**MONTGOMERY COUNTY HISTORIC PRESERVATION COMMISSION**  
**STAFF REPORT**

<b>Address:</b>	3905 Prospect St., Kensington	<b>Meeting Date:</b>	4/14/2021
<b>Resource:</b>	Secondary Resource <b>Kensington Historic District</b>	<b>Report Date:</b>	4/7/2021
<b>Applicant:</b>	Elihu Miles	<b>Public Notice:</b>	3/31/2021
<b>Review:</b>	HAWP	<b>Tax Credit:</b>	No
<b>Case No.:</b>	942700	<b>Staff:</b>	Dan Bruechert
<b>PROPOSAL:</b>	Solar Panel Installation

**STAFF RECOMMENDATION**

D1 - AR-01 - SCALE: 1/8" = 1'-0"

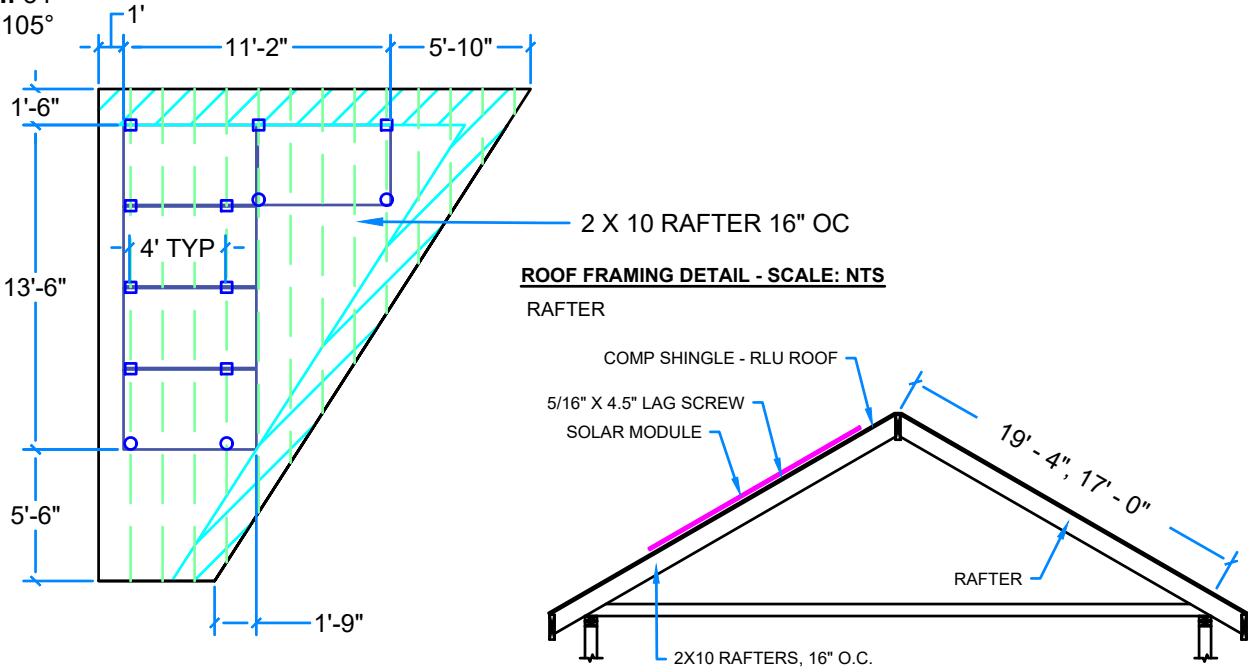
1. The approval does not extend to the seven solar panels in the southeast corner of the house (AR-04 and AR-01) or the four panels in the southwest corner of the house (AR-02 and AR-03). Revised drawings showing this condition has been met need to be submitted to Staff for review and final approval.

(labeled Array AR-04 and AR-01 on the submitted plan) will detract from the surrounding historic district and should not be supported under 24A-8(b)(1) and Standard 2. Connecticut Ave. is a major thoroughfare that cuts through the middle of the historic district and the views of the district from this perspective should be given additional consideration. Staff recommends the HPC add a condition for approval that the seven panels in the southeast corner of the house (AR-01 and AR-04) be eliminated from the proposal.

D2 - AR-02 - SCALE: 1/8" = 1'-0"

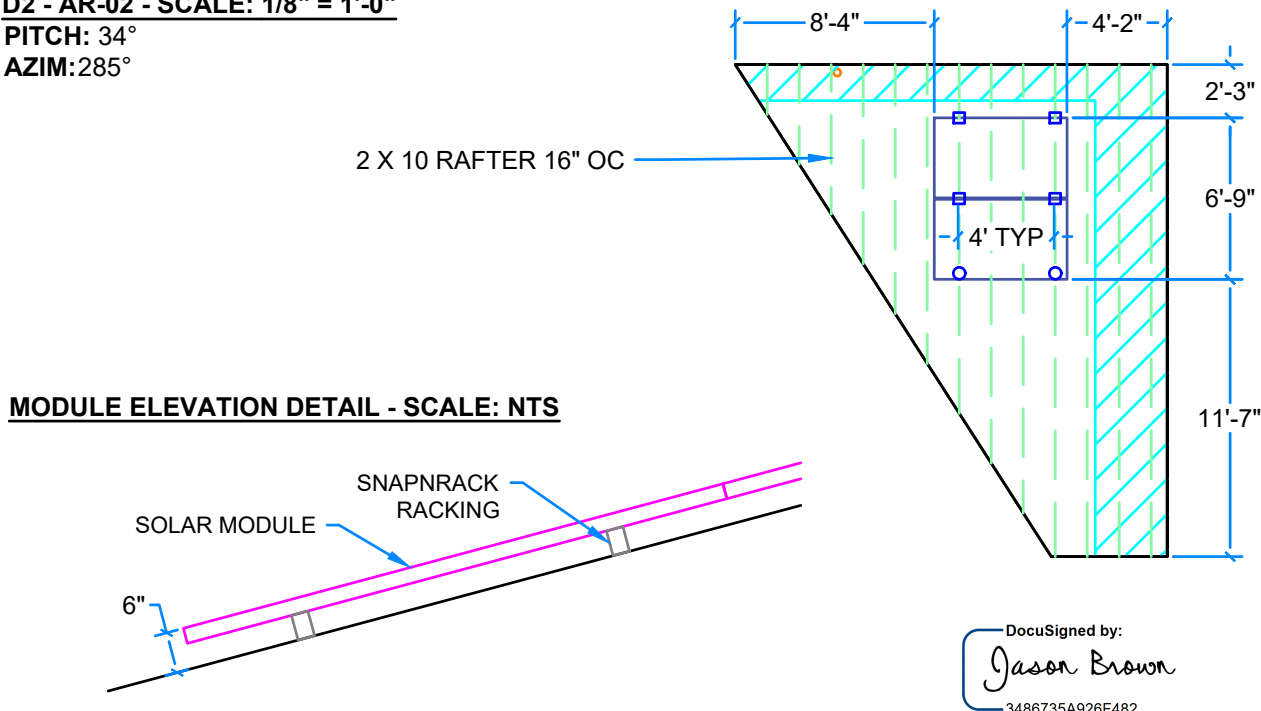
The remaining four solar panels are proposed in two arrays in the southwest corner of the house (see the photo below). These panels will not be visible from Connecticut Ave. In considering the appropriateness of these solar panels, Staff first considers the impact to the historic and architectural significance of the resource. This house was constructed in 2016 and does not have any historical significance, and its architectural importance is to reinforce building patterns found in the surrounding district. The next consideration is the visual impact on the surrounding district. The subject property is surrounded by both Primary and Secondary resources which contribute to the character of the surrounding district, defined as a “Victorian garden suburb.” Staff finds that the panels in the southwest corner identified as AR-2 and AR-3 detract from the character of the district, and the applicant has not provided supplemental information that demonstrates the project as infeasible without these panels. Staff recommends the HPC add a condition that these four panels in the southwest corner be eliminated from the proposal.
